SUPERFUND THIRD FIVE-YEAR REVIEW REPORT**for****A.L. Taylor (Valley of Drums)****Operable Unit 01****Brooks, Bullitt County, Kentucky****PREPARED BY:****US Army Corps of Engineers, Louisville District****for****US Environmental Protection Agency, Region 4
Atlanta, Georgia****February 2003**

SUPERFUND THIRD FIVE-YEAR REVIEW REPORT

A. L. Taylor (Valley of Drums)

Brooks, Bullitt County, Kentucky

Figure 5
ALT-03 Well Log

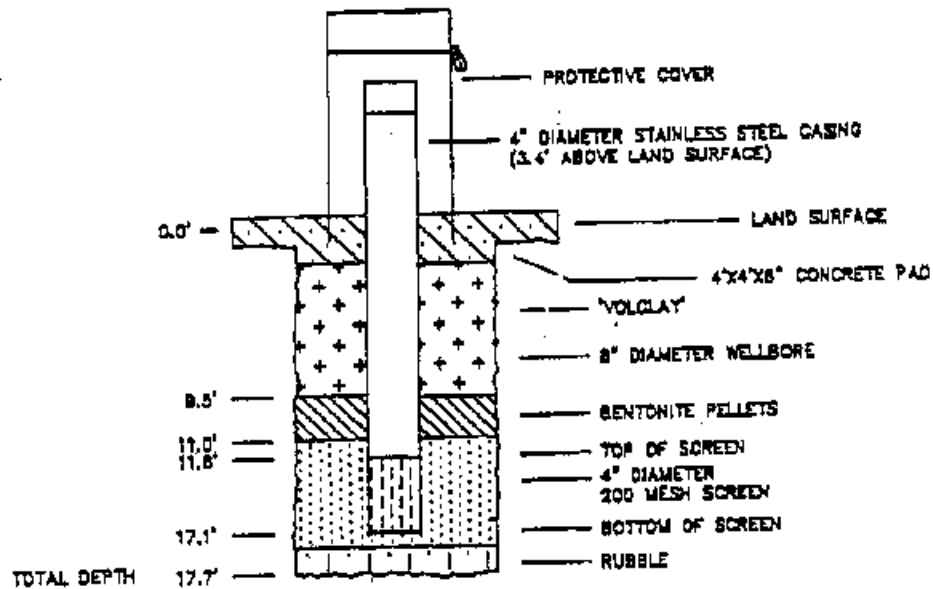
1. Well ALT-03 is a critical down-gradient sampling point known to have become fouled. Examination of the well section (Figure 5) indicates that the top of the well sand pack is less than 6-inches above the top of the well screen. For standard construction of wells it is preferred to have at least 2 feet of sand pack above the well screen to prevent the bentonite seal from impacting the screen. Based on the depth of the well, there is

sufficient room for 2 feet of sand pack and then the seal. The well has become fouled with silt and thus the well laboratory results could be in question. It is recommended that the well be surged and purged to remove the silt and the well re-developed and re-sampled. A replacement well may be necessary if ALT-03 cannot be re-developed.

Figure 6 - Sediment Sampling Locations
A. L. Taylor Superfund Site

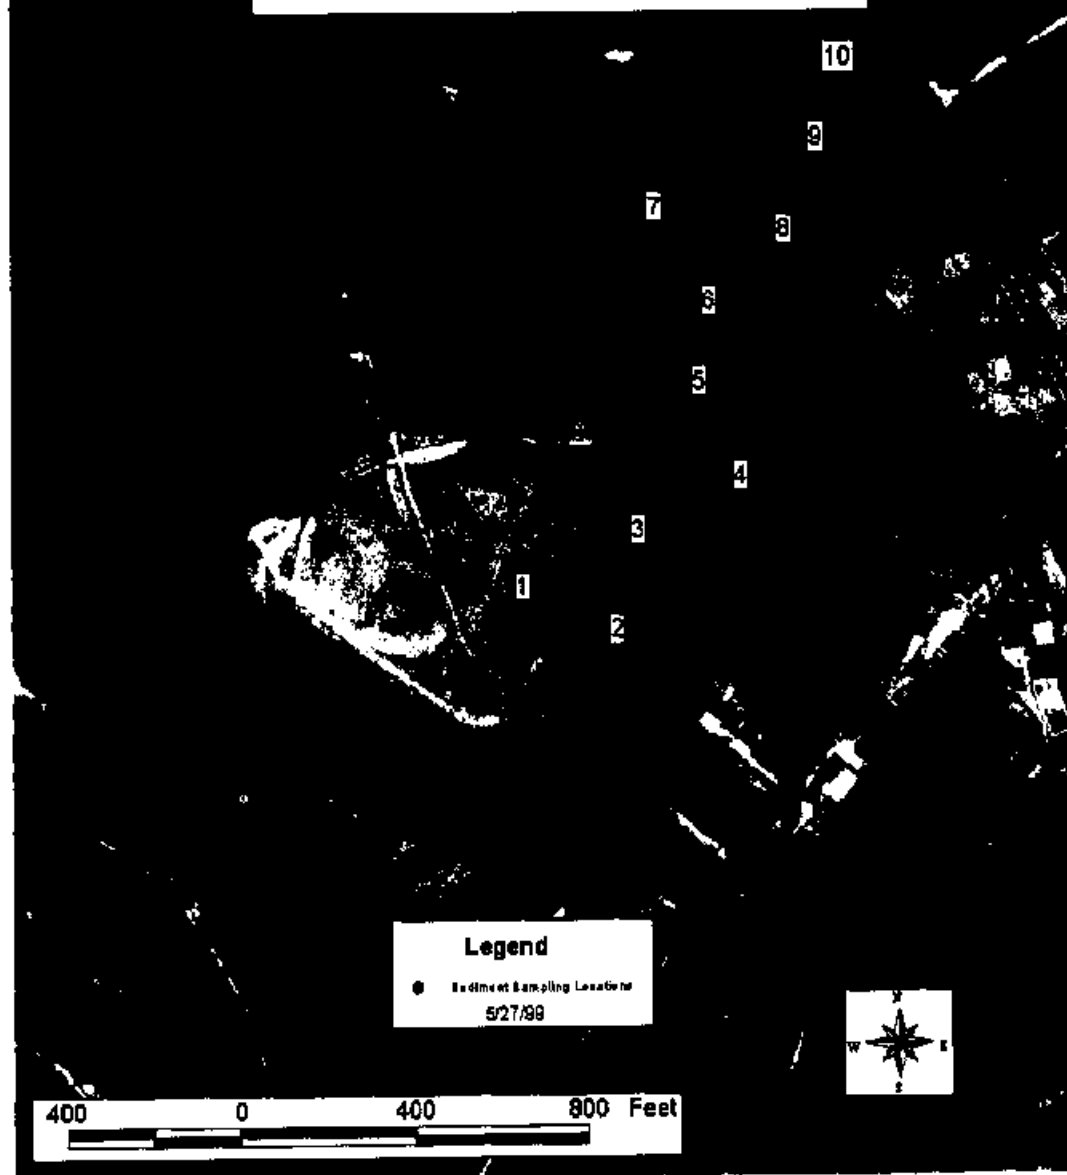
- Sediment samples were taken in Wilson Creek on January 8, 2003. Laboratory results reported 2.70 mg/Kg Arochlor 1254 from sample point SD-5 (Figure 6) and 1.27 mg/Kg Arochlor 1254 from sample point SD-9 (Figure 6).

Sediment. During the 1998 sampling, no PCBs were detected in sediment samples taken from sample points SD-06 (pond), SD-07 (north swale), SWD-08 (north ditch), SD-09 (south swale), SD-10 (pond outlet), or SD-11 (Wilson Creek downstream). During the 1999 sampling, Aroclor 1254 was detected in sediment samples taken from sample points 01, and 03 through 08. Aroclor was also detected at sampling points 02, 07, and 08 (Figure 6). Sediment samples taken in Wilson Creek on January 8, 2003, as part of the 2002 data collection effort, reported 2.70 mg/Kg Arochlor 1254 from sample point 05 and 1.27 mg/Kg Arochlor 1254 from sample point 09 (Figure 6).
